RE: Port Pheonix Water Way Marina – DCI2023-00054 – Major PD

Please find below responses and commentary to the provided comments from staff in your January 7th, 2025 letter regarding the Commercial Planned Development Application for Port Pheonix Water Way Marina (DCI2023-00054).

WB-40 SEMI-TRAILER INTERMEDIATE TRUCK SPECIFICATIONS:
OVERALL LENGTH: 45.5'
OVERALL WIDTH: 8.0'
WALL TO WALL RADIUS: 41.017'

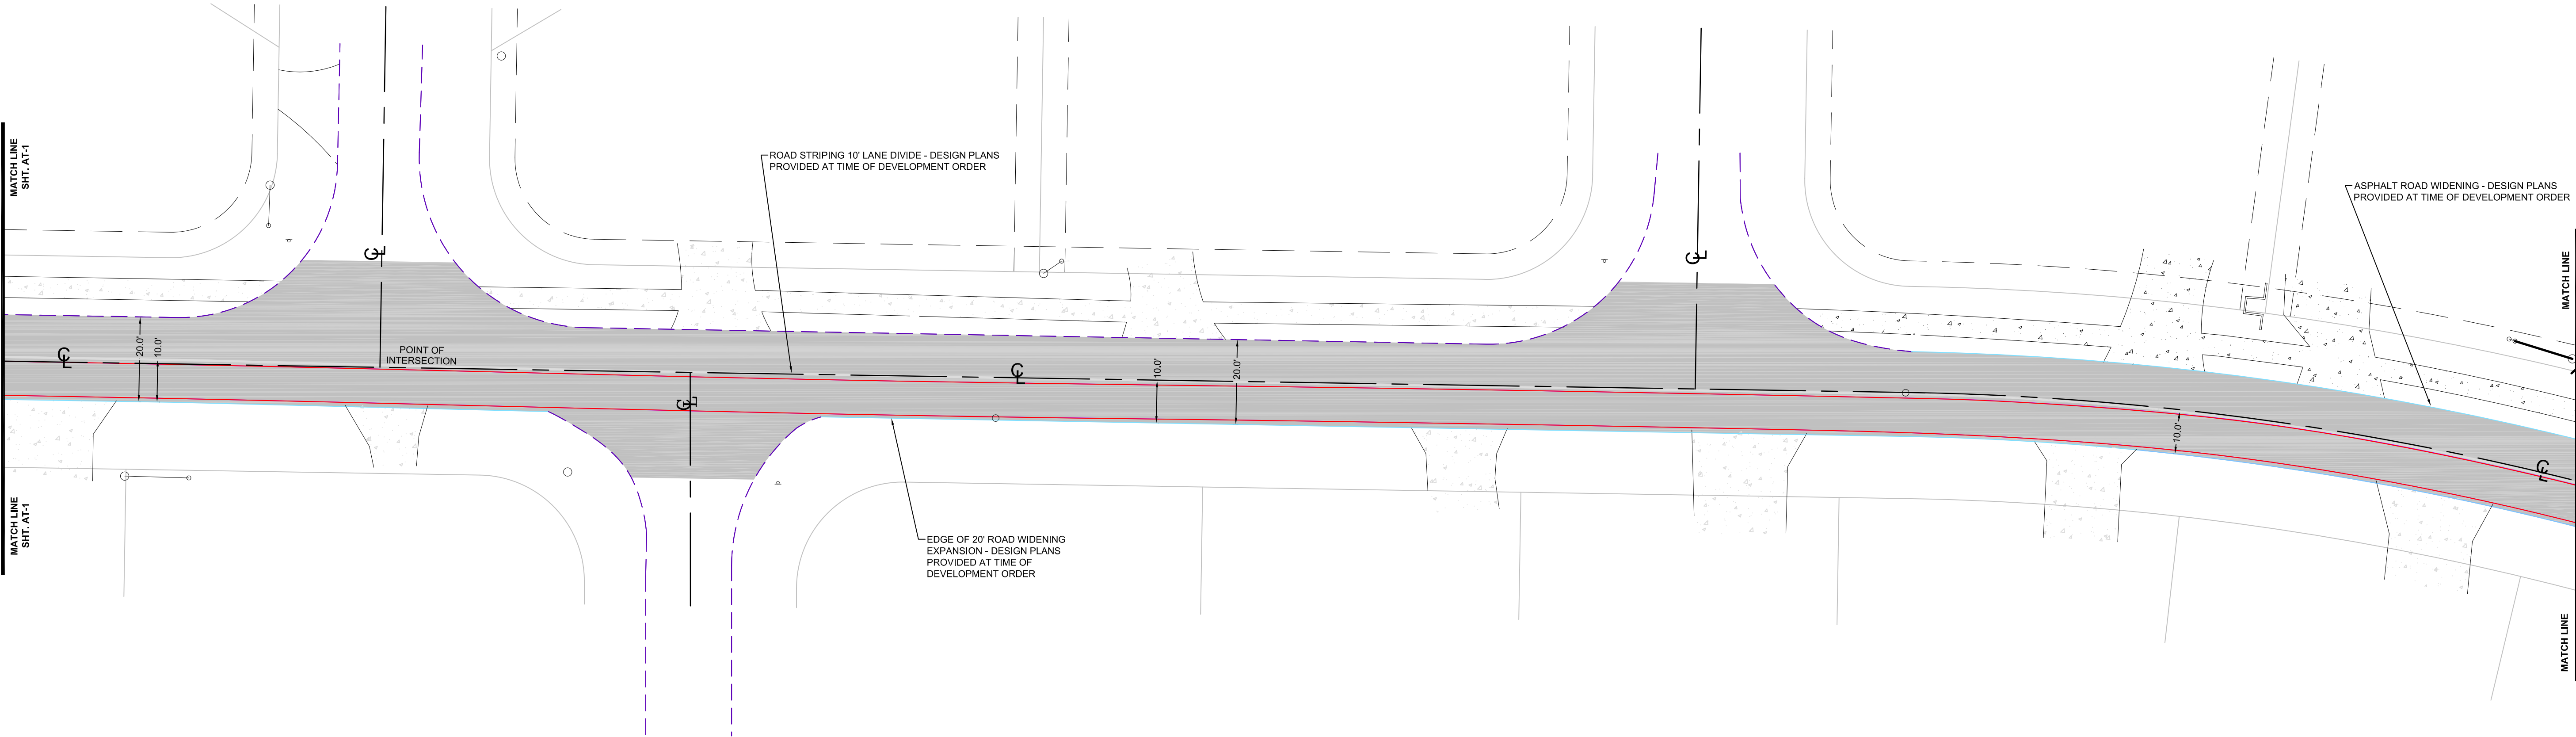
1. *Provide the Inlet Dr road widening exhibit showing information on the proposed asphalt road widening as specified in the WB-40 AutoTURN Exhibit.*

Per coordination with Brian Roberts, it is understood that this comment relates to a note regarding additional minor asphalt changes that were included in the auto-turn Exhibit. We have revised the conflicting note for clarity. Any required road modifications will be permitted at the time of Development Order submittal. Please refer to the updated Auto turn Exhibit.
